## C2032x MAIN FIRMWARE RELEASE NOTES

### Uni-7 Series with PK-260B CPU Board

C2032x supersedes B0779x as the standard Uni-7 firmware for the revised PK-260B CPU board.

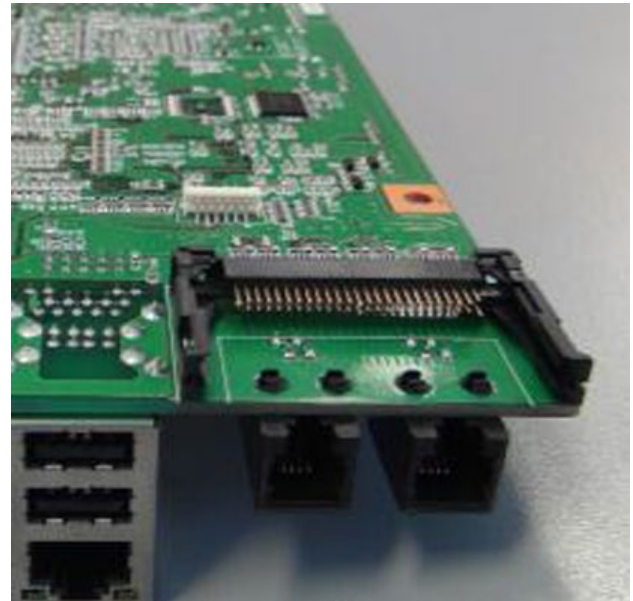
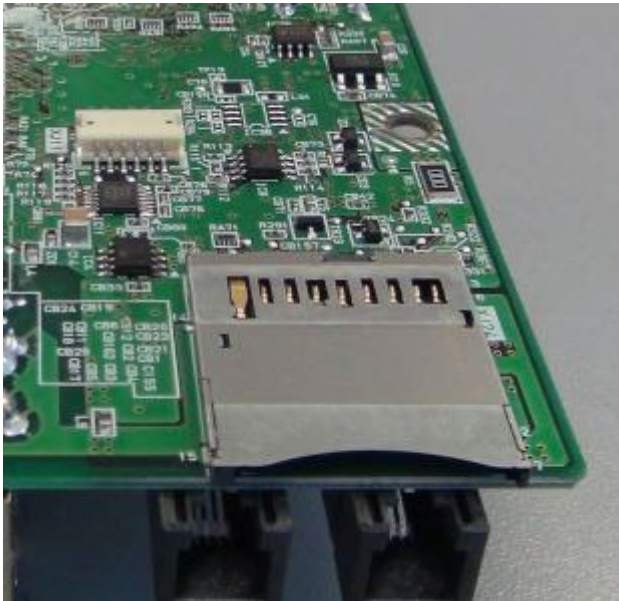
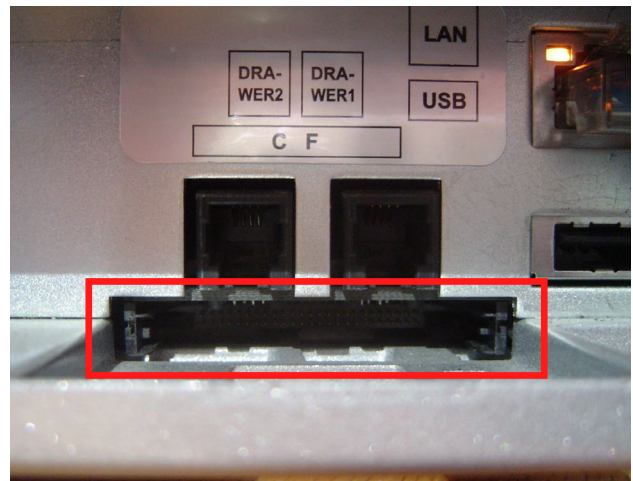
Firmware C2032x is designed for the revised CPU board PK-260B. **This firmware is not compatible with the previous CPU board PK-260A.** And previous firmware (B0674x, C1991x, etc.) is not compatible with the new PK-260B CPU board.

The two CPU board versions can be easily identified by the expansion memory card slot located on the left side of the Uni-7. See the images below.
